DESIGN REVIEW: RECOMMENDATION

1422 SENECA STREET, SEATTLE, WA 98101

PROJECT #:3034493-EG

ENLARGED SITE PLAN OF BUS STOP

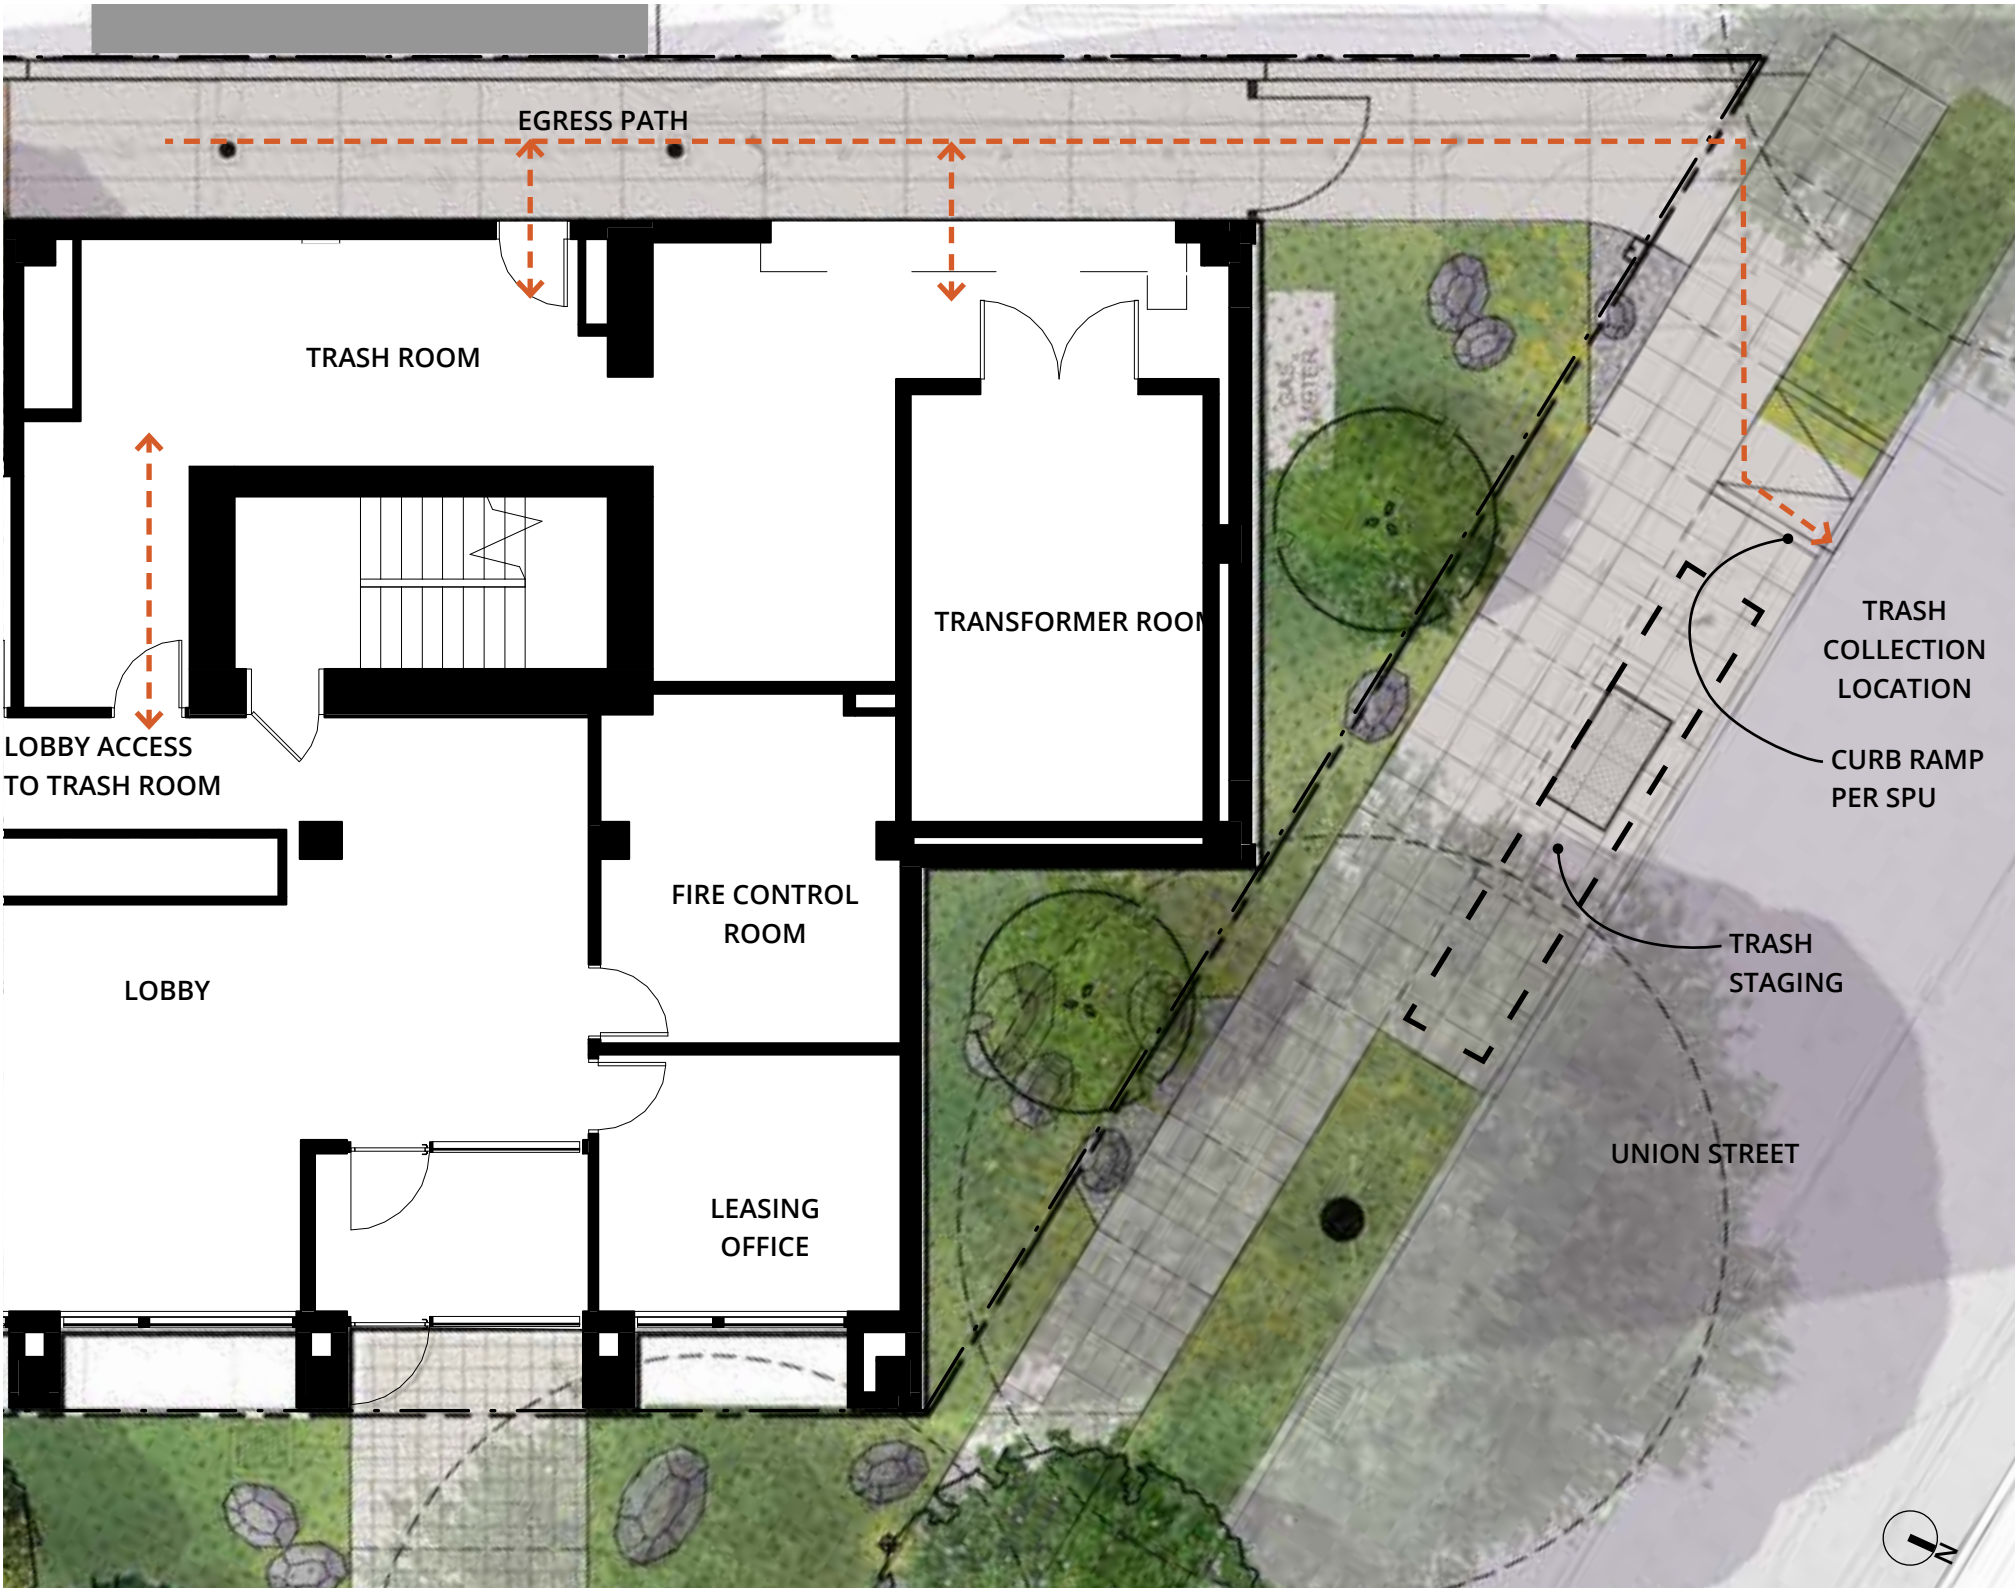
The Board supported the provision of additional space for the bus stop on Seneca St.

The Building massing is setback at the bus stop to provide relief at the bus stop. The landscape plan has been developed to include benches and additional paving as a benefit to public transit riders along Seneca Street.

DEPARTURE MATRIX [8.0]

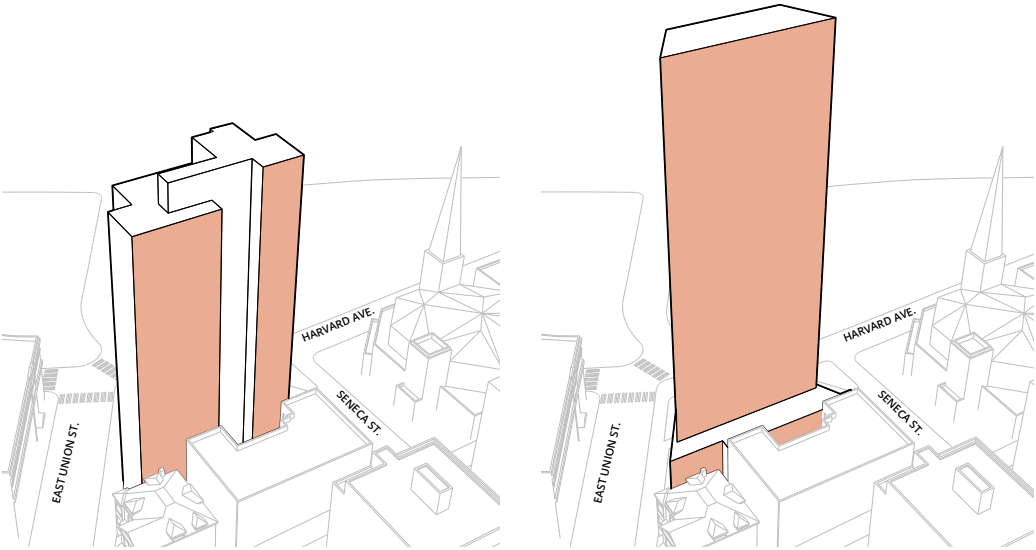
The Board expressed qualified support for the requested departures, recognizing their importance in creating a viable project on this unusual site and their expectation of highest quality design solutions given the magnitude of the requests.

The Board agreed that for the departures to be considered, a clear rationale would be required demonstrating how they help the project better meet the intent of adopted design guidelines.

The current design is consistent with the preferred scheme at EDG that was supported by the board. Dri-design metal panel is being proposed at the metal panel with a wood textured metal panel. All facades are being designed with the high quality materiality, since this will be a prominent, iconic building in the neighborhood.

The departures allow the design to be a thinner, rigorous, iconic tower as opposed to a building with the prescribed setbacks. In addition, mass timber would not be feasible with the code prescribed setbacks.
